## APPLICATION FOR CERTIFICATE OF APPROPRIATENESS

Address 3312 East Broad Street

Historic district Chimborazo

**Project Description – 3312 East Broad Street**

FRONT / REAR  
ELEVATIONS

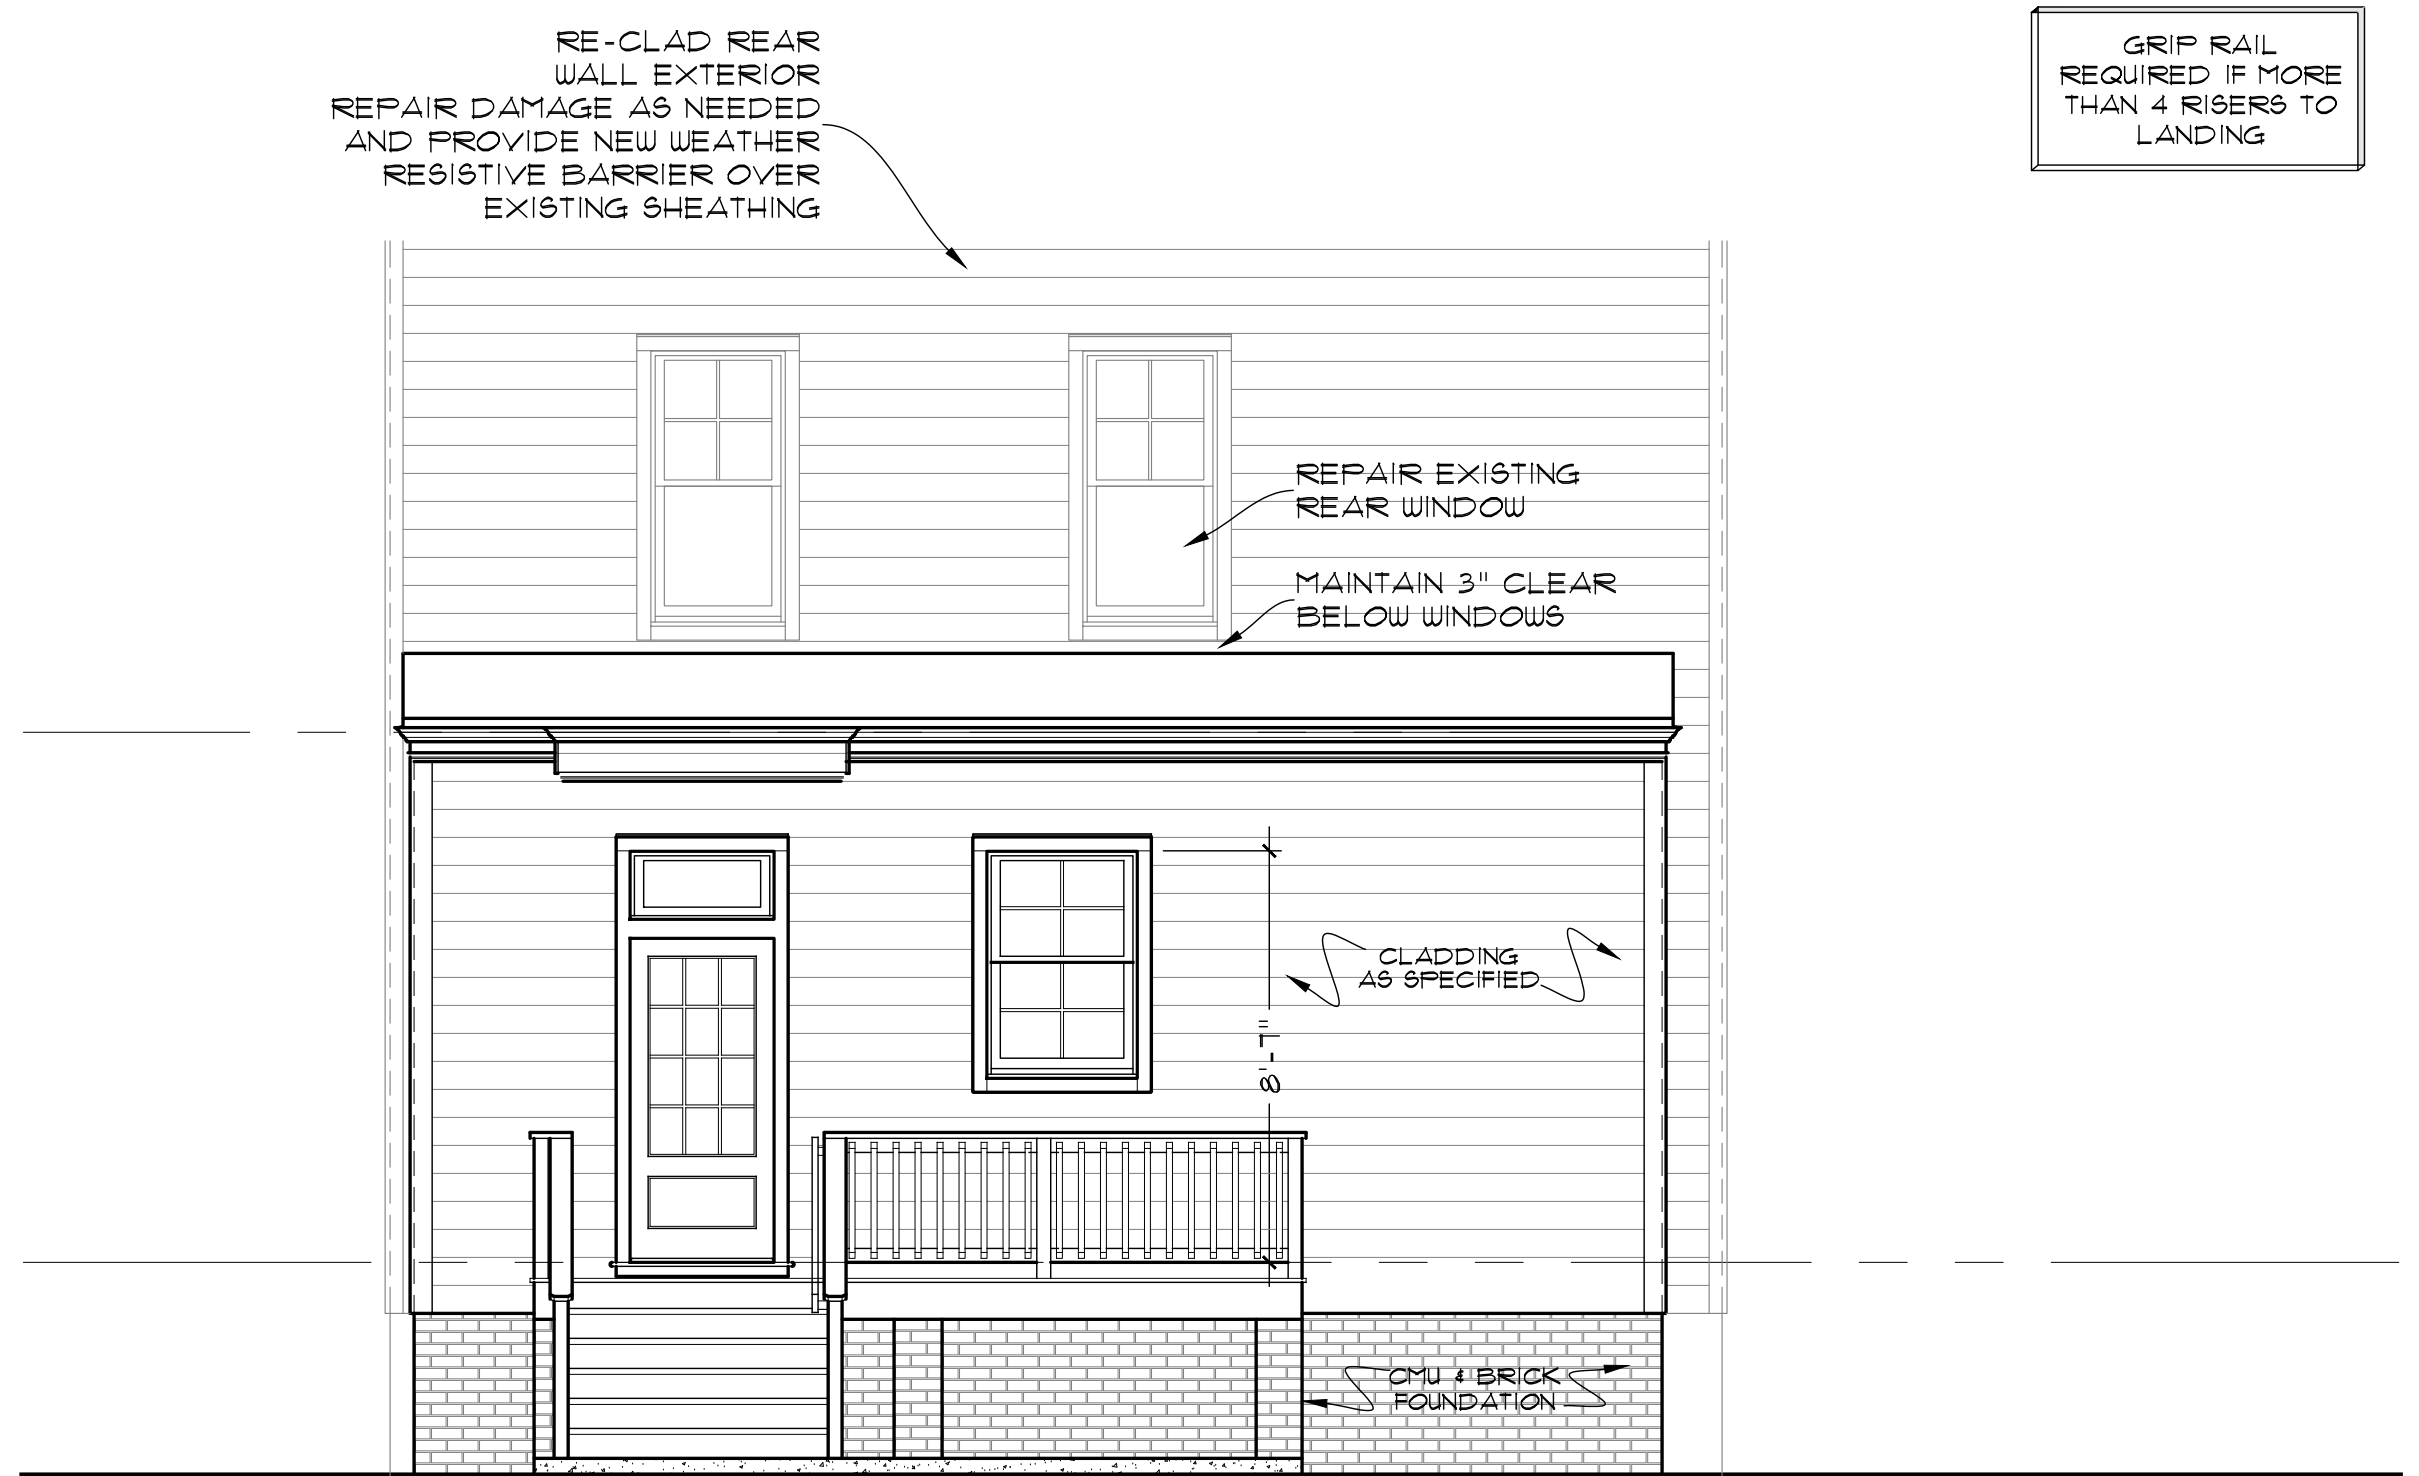
- Can you provide the exterior height of the proposed addition?
- Can you confirm the window specifications? The application mentions a 1/1 window, however the plans show a multi-light window.

The exterior height of the proposed addition is 208-inches above grade next to the existing structure. It is to start approximately 5-inches below the windows on the second floor (the exposed width of one row of siding). It goes down to 185-inches at the end of the proposed addition. Please let me know if this is the information you are looking for.

On the windows, they will be 2-over-2 windows. Sorry for the error.

Figure 1. Rear elevation, 1987

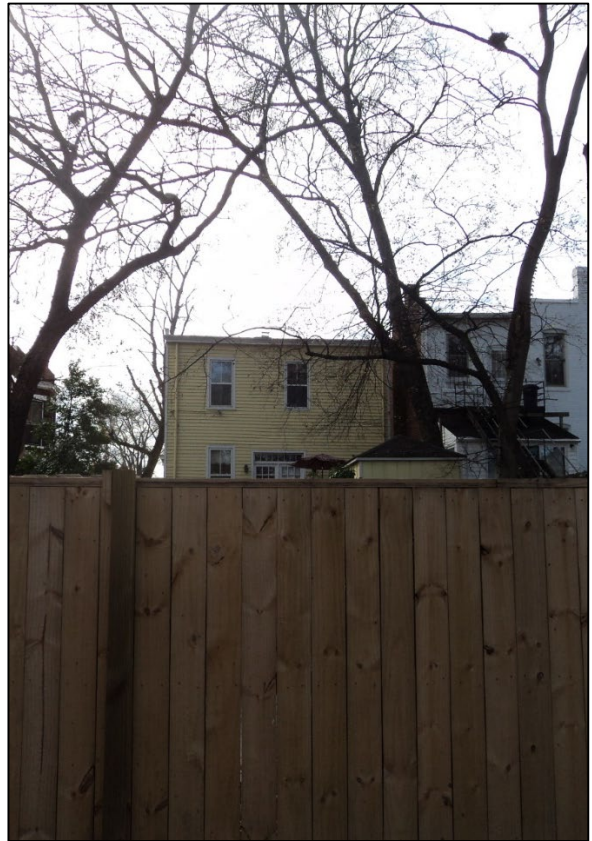
- The fenestration pattern on the side and rear elevations of the addition should be revised to be more consistent with patterns found on the home and within the district.
- The following information should be submitted for final review:
  - Materials details
  - Fully dimensioned plans, including head and sill heights
  - A window and door schedule
